SUBJECT: ISSUANCE OF AMENDMENT (TAC NO. 79628)

The Commission has issued the enclosed Amendment No. 61 to Facility Operating License No. NPF-49 for Millstone Nuclear Power Station, Unit No. 3, in response to your application dated January 18, 1991 as supplemented by letters dated April 5, 1991 and April 8, 1991.

MILLSTONE NUCLEAR POWER STATION, UNIT NO. 3

Amendment No. 61
License No. NPF-49

FIGURE 3.6-2
 HYDROGEN RECOMBINER ACCEPTANCE CRITERIA
 FLOW VS CONTAINMENT PRESSURE *

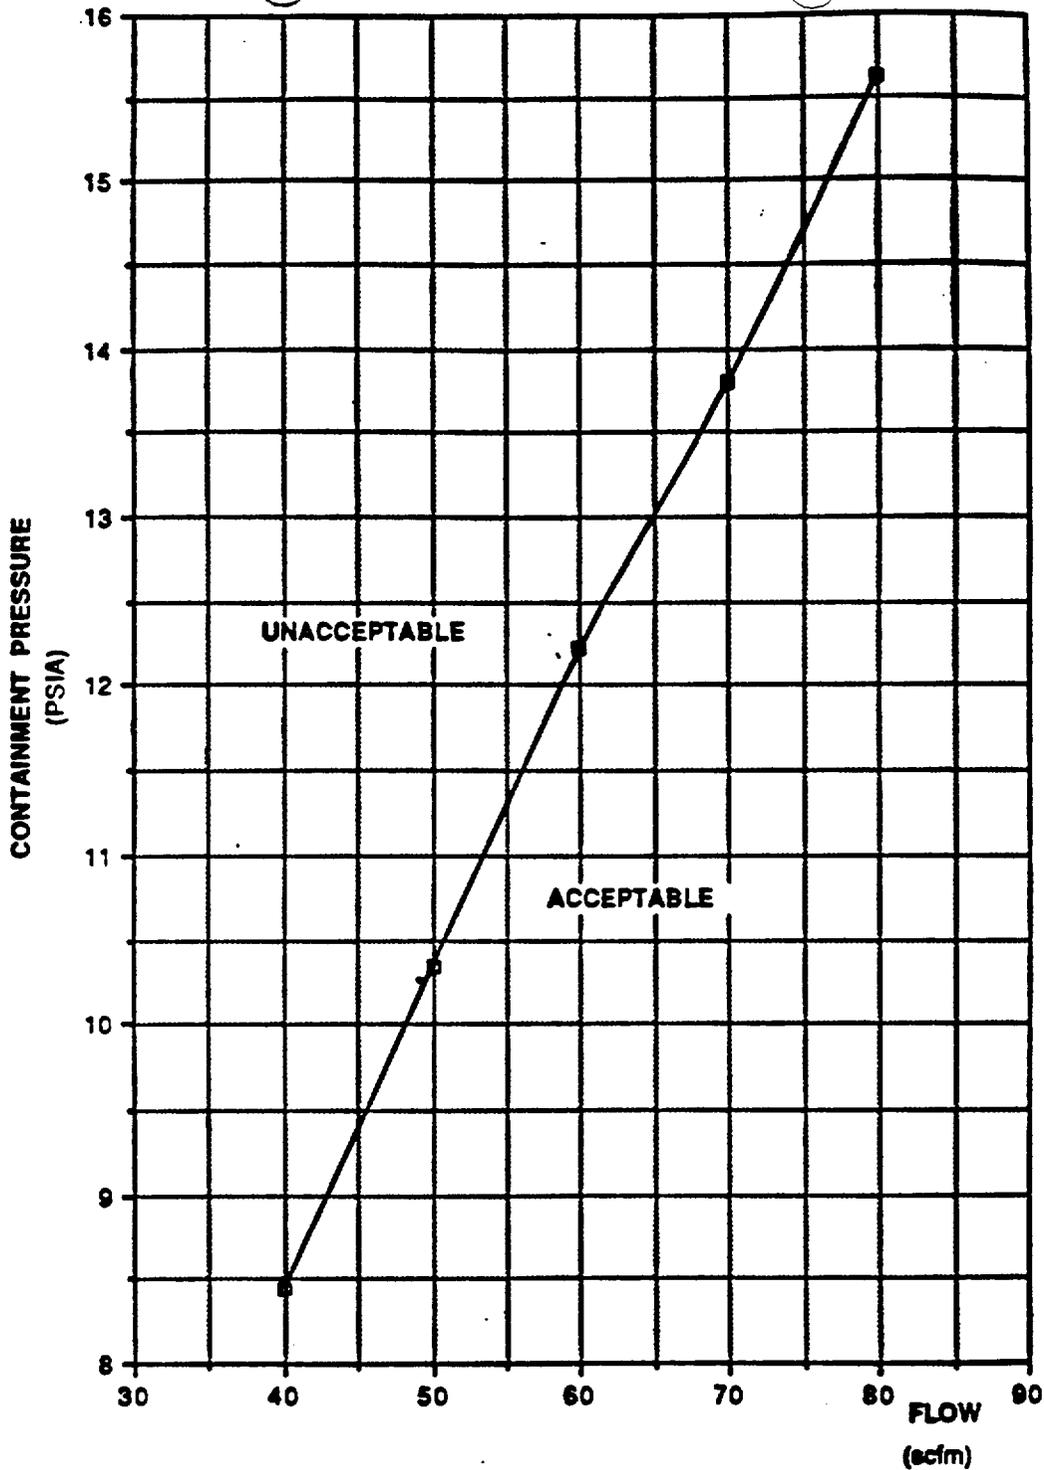
The amendment changes Technical Specification (TS) 4.6.4.2.b.4, "Electric Hydrogen Recombiners," and adds the following note to the pressure - dependent flow requirements for the hydrogen recombiners in TS Figure 3.6-2:

Since the issuance of TS Figure 3.6-2 on March 2, 1990 (License Amendment 47), new technical information has been received, by NNECO, from the hydrogen recombiner blower manufacturer, M-D Pneumatics, which indicates that the information used to generate Figure 3.6-2 was not appropriate and was overly conservative. This has resulted in the recent test failures. Figure 3.6-2 was developed using generic information for this type of blower. NNECO's letter of April 5, 1991, as supplemented by letter dated April 8, 1991, proposed that the following footnote be added to TS Figure 3.6-2:

Hydrogen recombiner (A) passed the surveillance test as required by the current TS, as a result of subsequent testing. Recombiner (B) fell short of the TS flow rate requirement by only 2% when it was tested. The licensee's analysis shows that there is substantial margin between the flow rate required by the current TS and the flow rate that would actually be required during a LOCA for the recombiner to fulfill its design function. Although the staff has not completed a detailed review of the licensee's analysis, there is reasonable assurance that the small shortfall in flow rate has not rendered the recombiner inoperable. The proposed TS reduces the required flow rate slightly and thus would allow the licensee to declare both recombiners to be operable, having satisfied the new surveillance acceptance criteria. Therefore, for the relatively short time period allowed by the proposed TS, and considering the relatively low probability of a LOCA occurring during that period, the staff finds that the proposed TS is acceptable.

*Until September 30, 1991, a flow rate of 72.4 scfm or greater at a pressure of 14.5 to 14.8 psia is acceptable in lieu of the values indicated by Figure 3.6-2.
